Circular letter nr. 08/2011

Subject : PowerCube PB1/F mounting frame.

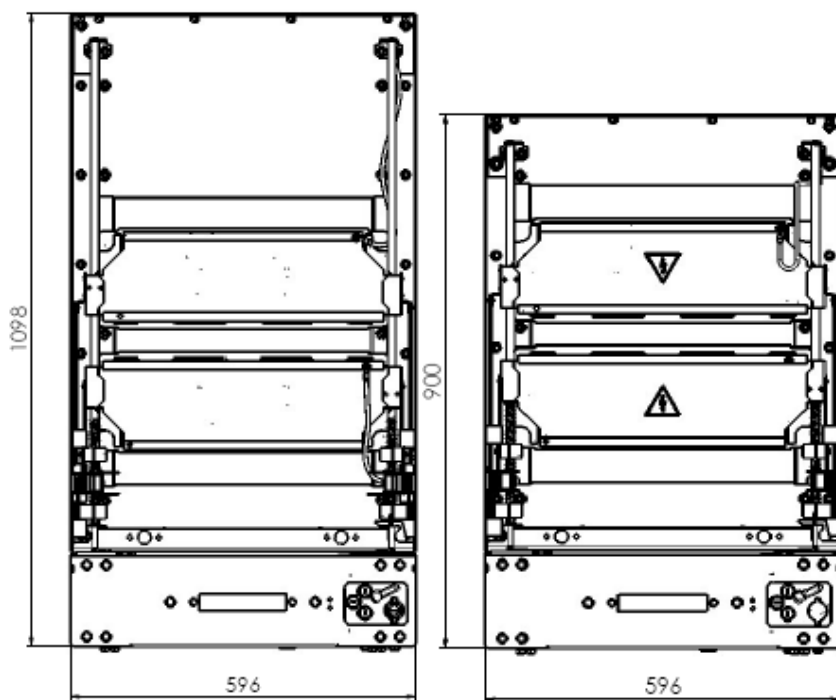
1. The following modification will be implemented on the PowerCube PB1/F mounting frame:

The total height of PB1/F will be reduced from 1098mm to 900mm as per the below drawings

The purpose of the modification is to increase the flexibility of use of the mounting frame.

The introduction of the modification will apply to orders placed from 01/01/2012 Best Regards,
